RE: CLARIFICATION NO. 1 AND ADDENDUM NO. 1 TO THE BIDDING DOCUMENTS FOR UPGRADING OF IRINGA (IPOGOLO) – KILOLO REGIONAL ROAD (33.61KM) TO BITUMEN STANDARD, TENDER NO.: AE/001/2022-2023/HQ/W/38

UPGRADING OF IRINGA (IPOGOLO) – KILOLO REGIONAL ROAD (33.61KM) TO
BITUMEN STANDARD

Clarification No. 1 to the Bidding Documents

Addendum No. 1 to the Bidding Documents

Project No: **T533-CE-RD-SD-06**
 TSS3

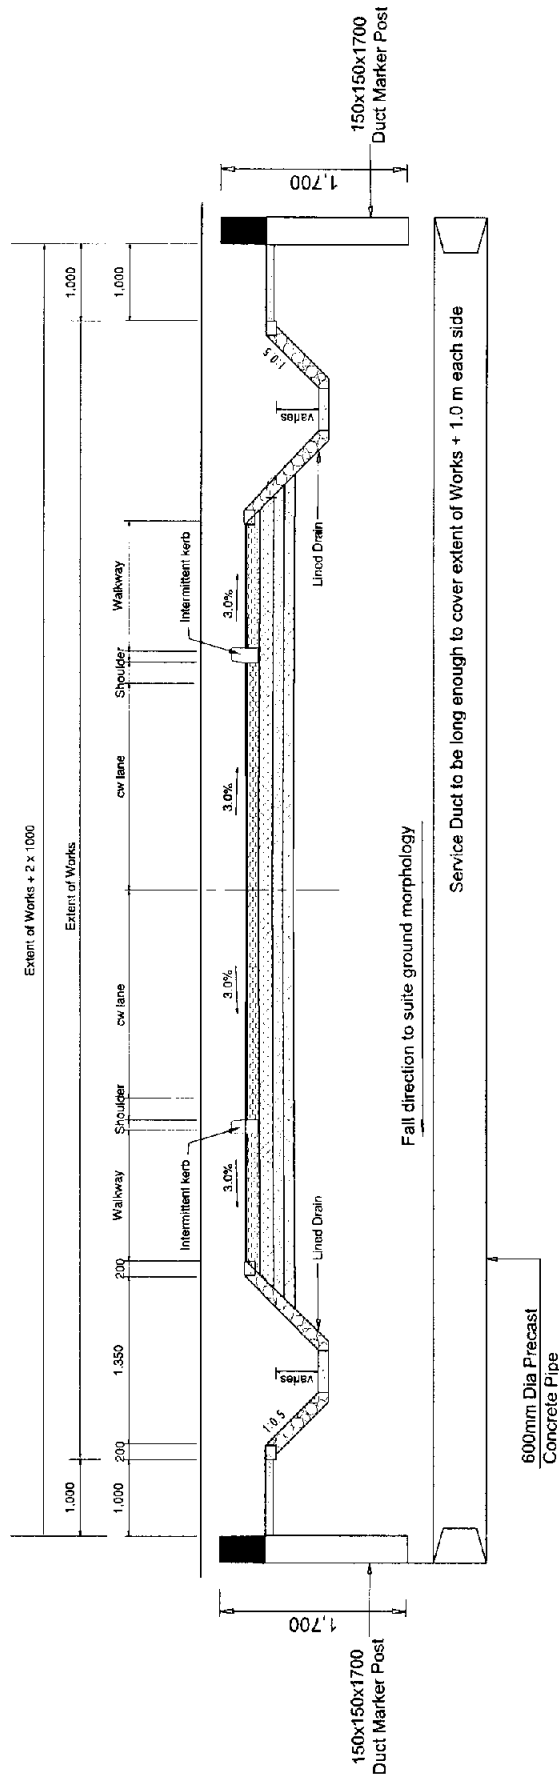
S/N	Issues/Questions	Clarifications/Responses
1.	For BoQ, Item 22.23 Service Ducts. According to the drawing, the services ducts are 300mm PVC material, but in the BoQ it is not included BoQ, please clarify this	<i>The drawing showing service duct of 300mm PVC to be omitted. The service duct shall be of 600mm diameter concrete pipe as detailed on drawing no. T533-CE-RD-SD-06.</i> <i>Please refer Item No. 3 of Addendum No. 1.</i>
2.	For BoQ, Item 5600 Bus stop shelters. According to the drawing, there are several bus stop shelter, but in the BoQ it is not included, please clarify this	<i>Add item 56.02 in the BoQ to read as follows; Construction of bus stop shelters consisting of concrete class 20/20 finishing with 50mm tubular hollow sections frames, roofed as per drawing no. T533-CE-RD-SD-07. The item has the quantity of unit No. of 40</i>

Add missing drawing no. T533-CE-RD-SD-06. Please refer **Appendix 1**.
